**Reference: SEZAD Tender No. (19-2015) "EPC Construction Services for Detailed Design and Construction of the Duqm Refinery Service Corridor to the Liquid Jetty"**

### Subject: Reply to Queries

**Circular No. (3)**

**SCHEDULE OF SLEEPER & TIE BEAM**

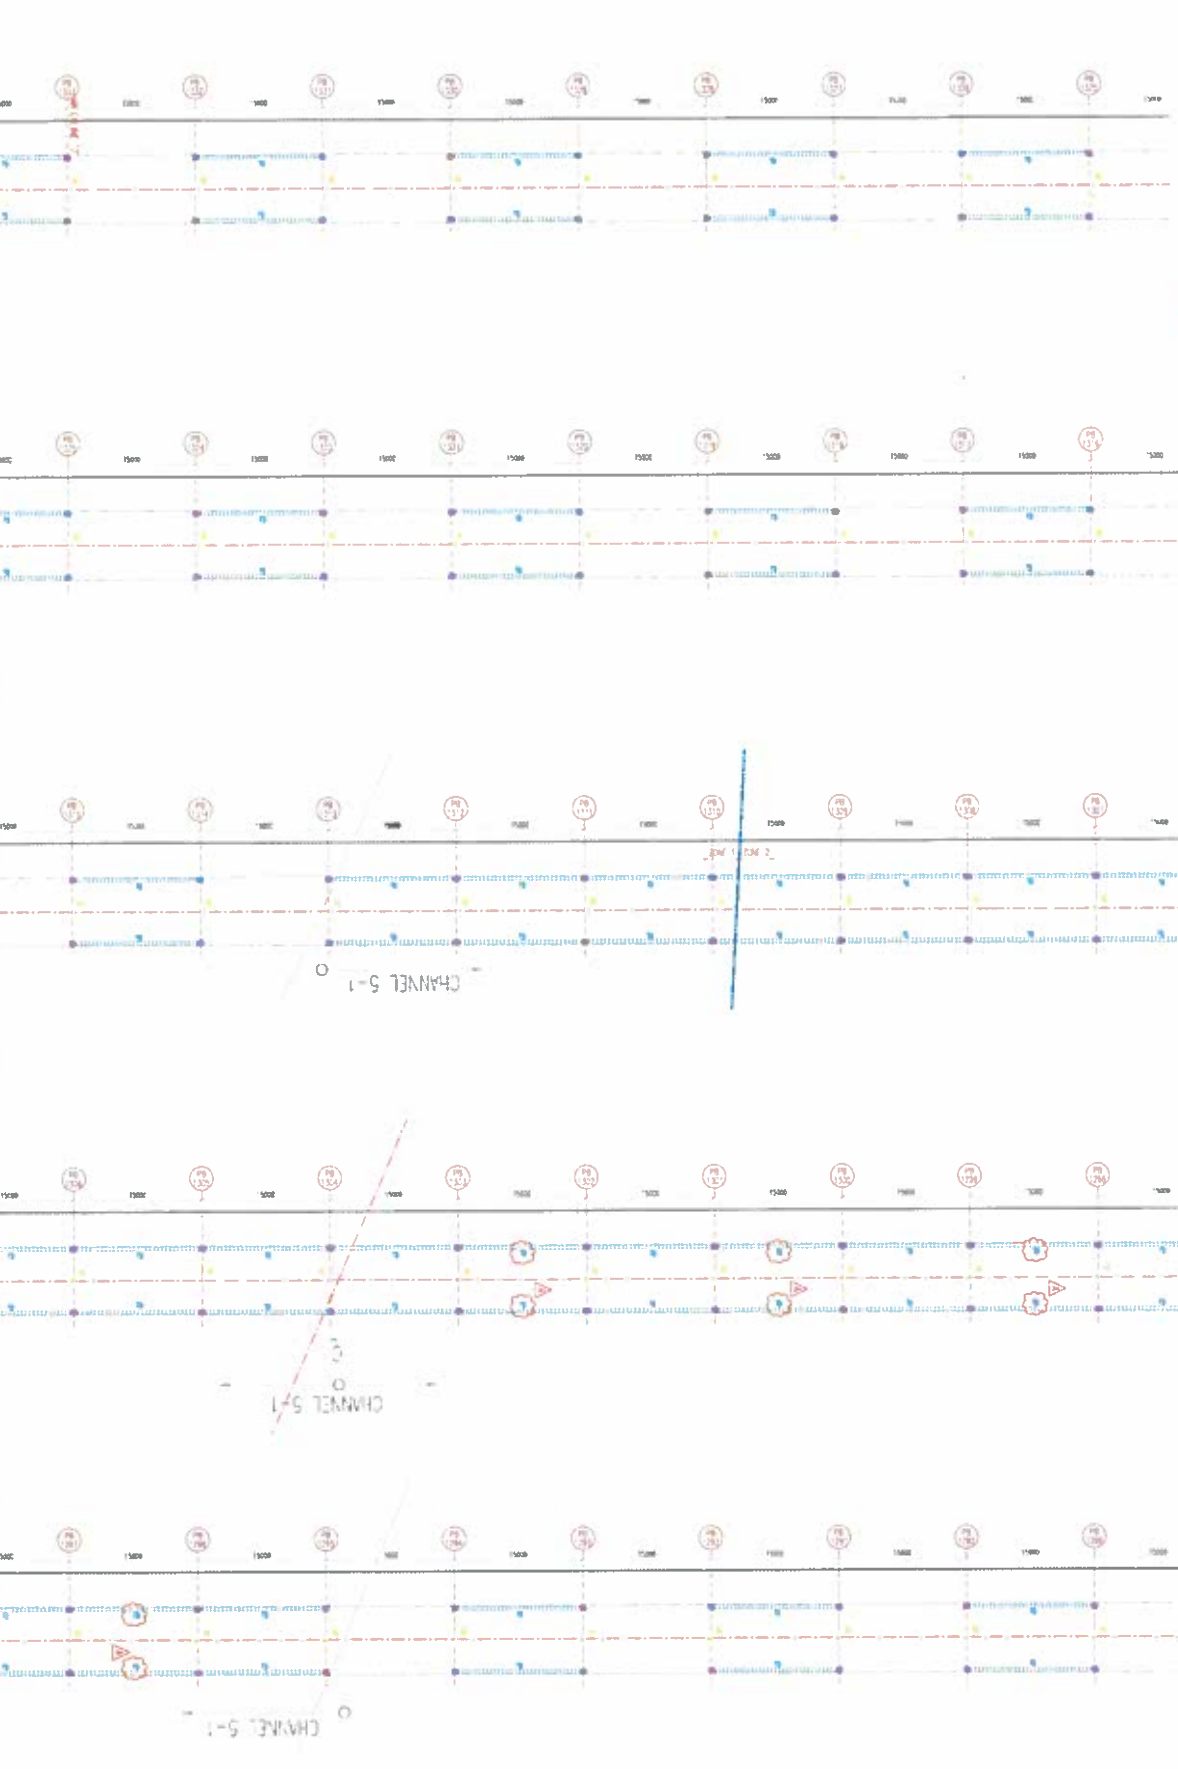
10.	Drawing 1409/DUQM/120/SE indicates a hit /miss arrangement for the tie beams across part of the Channel 5-1 (PB 1295 to PB 1303). Please confirm if this is correct or is it a design error and the tie beams should be continuous as per the bridge over Wadi Saay.		The tie beams should be continuous throughout, as per the stretch from PB1313 to PB1304. Hence, there should be an additional 8 (=4x2) nos. of tie beams. Please refer to amended drawing 1409/DUQM/120/SE/A. provided with this circular.
